HARTZELL PROPELLER INC.
SERVICE BULLETIN
HC-SB-61-327

Propeller - Inspection of D-4511(L)(P) Spinner

Figure 1

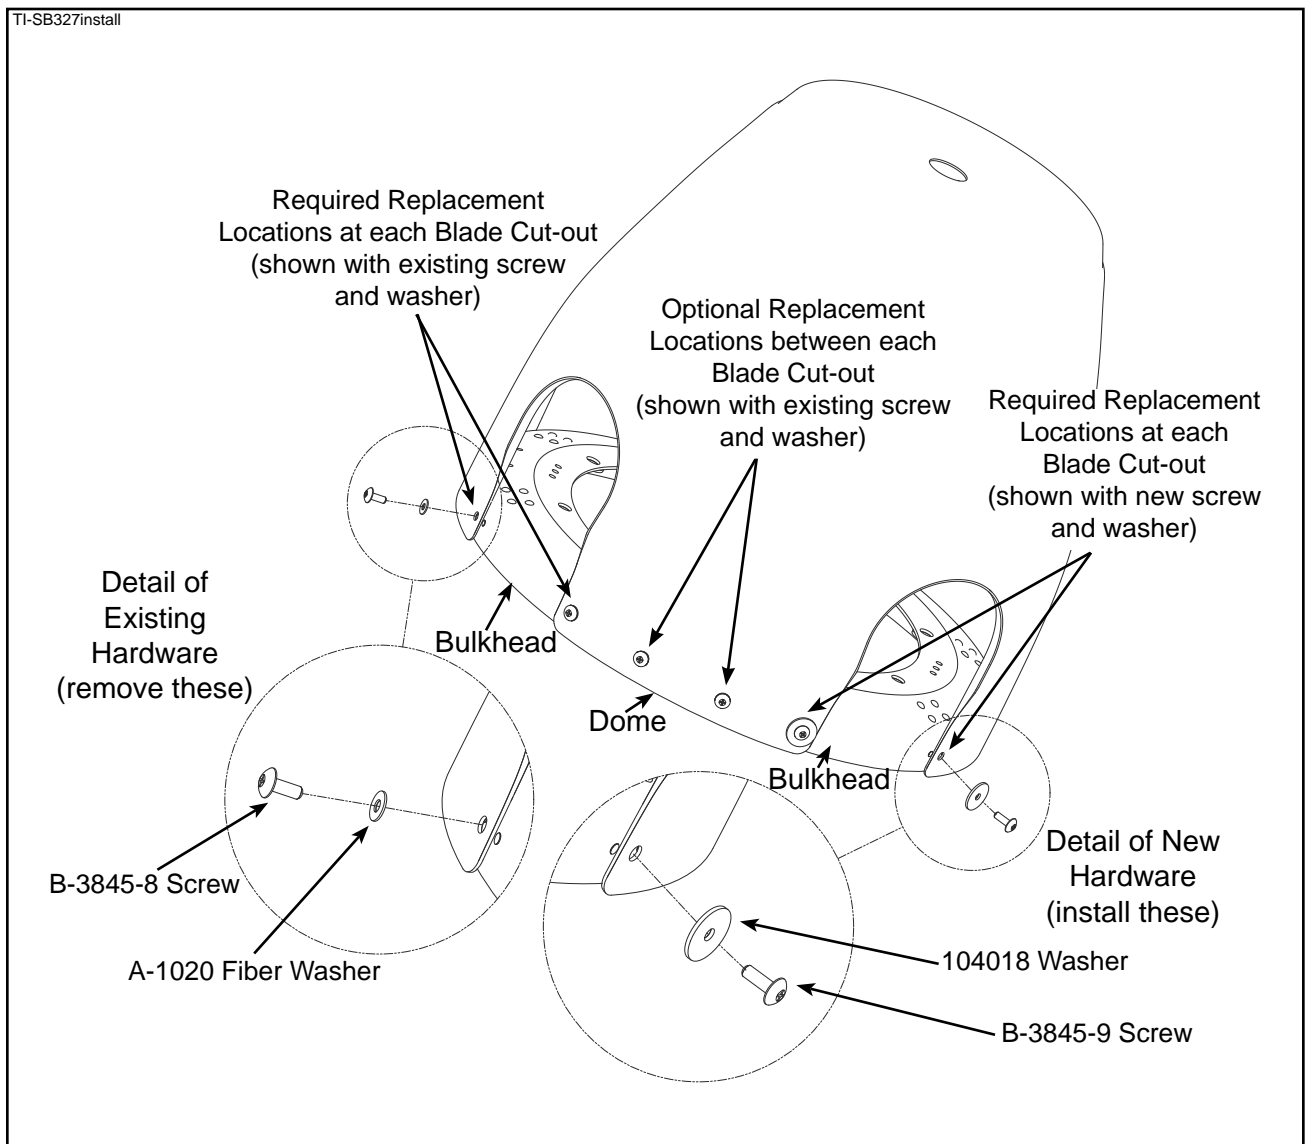
- (1) The D-4512-2(L)(P) spinner dome in the D-4511-(L)(P) spinner assembly has had in-service cracking events, causing a high replacement rate.
- (2) A large area washer, part number 104018, and longer screw, part number B-3845-9, have been introduced to provide support to the stressed area and reduce cracking issues.
- (3) This Service Bulletin is a temporary measure until a new spinner dome or assembly can be designed to eliminate cracking issues on the affected applications.
- (4) Regulatory action is not expected.

- (e) Using eight (8) of the 104018 washers and eight (8) of the B-3845-9 screws in the locations identified in Figure 1, as an alternative to eight (8) of the removed fiber washers and screws, install the spinner dome in accordance with Hartzell Owner's Manual 115N (61-00-15).
 - 1 Replacement of the washers and screws in only the eight (8) locations identified in Figure 1 are required for Terminating Action of this Service Bulletin.
 - 2 At the discretion of the owner/operator, all 16 removed fiber washers and screws may be replaced with the 104018 washer and the B-3845-9 screw.
 - 3 After installation is complete, discard all remaining washers and screws.

- (b) Installation of the washers, part number 104018, and longer screws, part number B-3845-9, in accordance with the Accomplishment Instructions in this Service Bulletin is terminating action for this Service Bulletin.
